RETREAT AT TIMBERRIDGE FILING NO. 2

CONSTRUCTION DRAWINGS

MARCH 2021

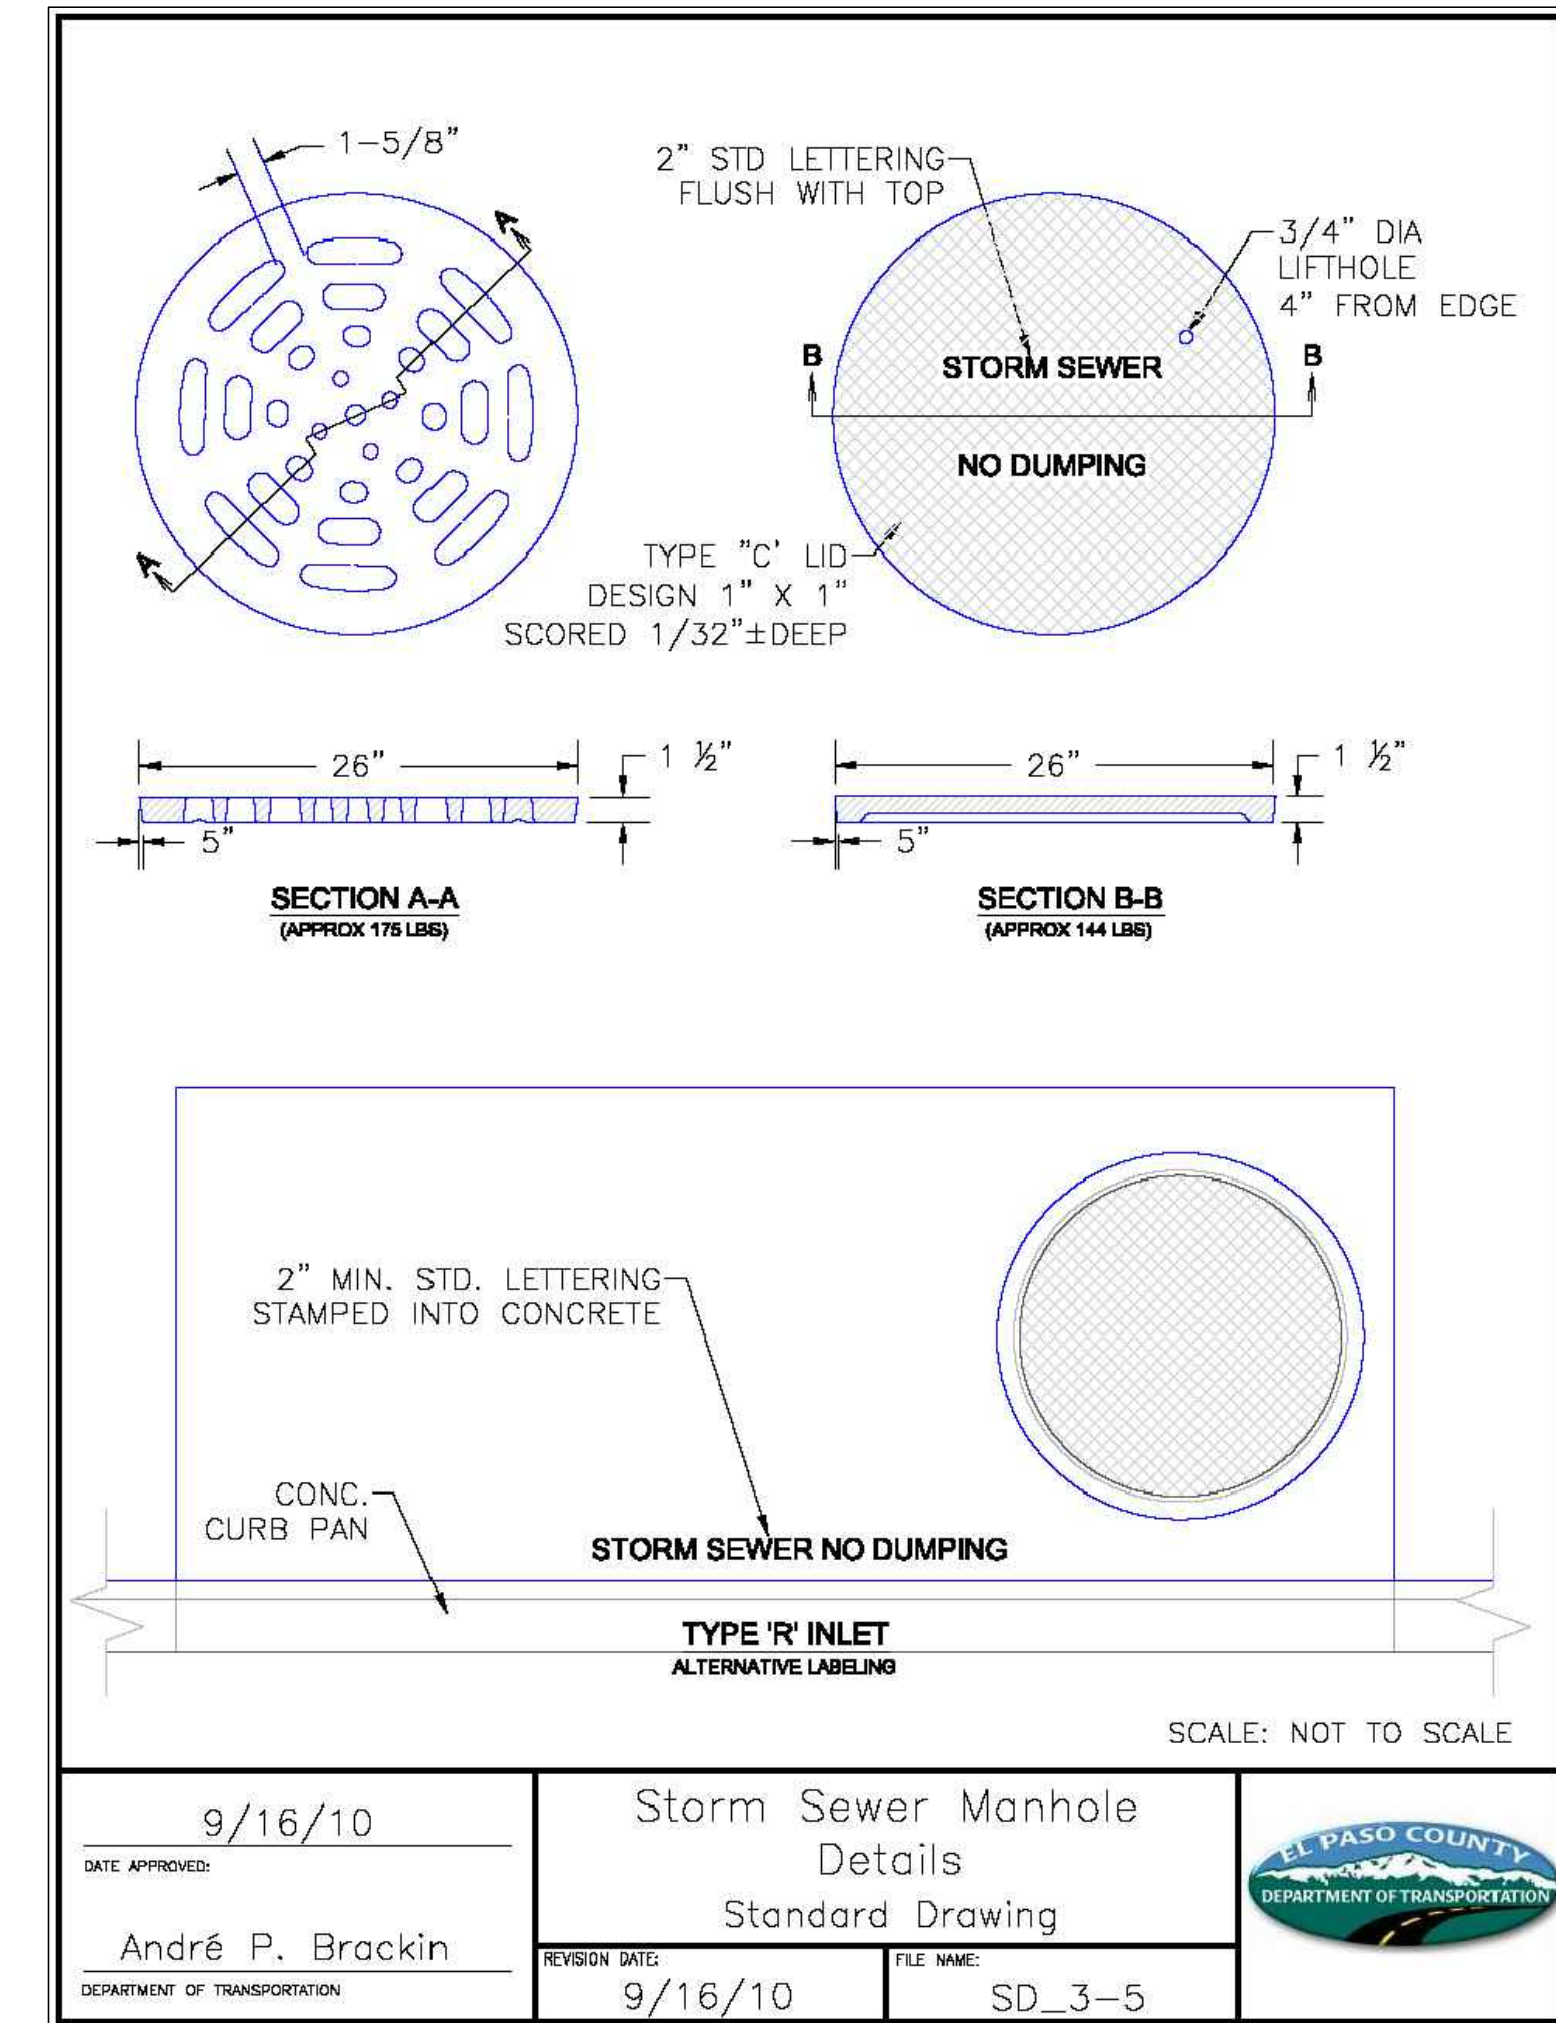
Include detail for curb inlet protection.
Unresolved.
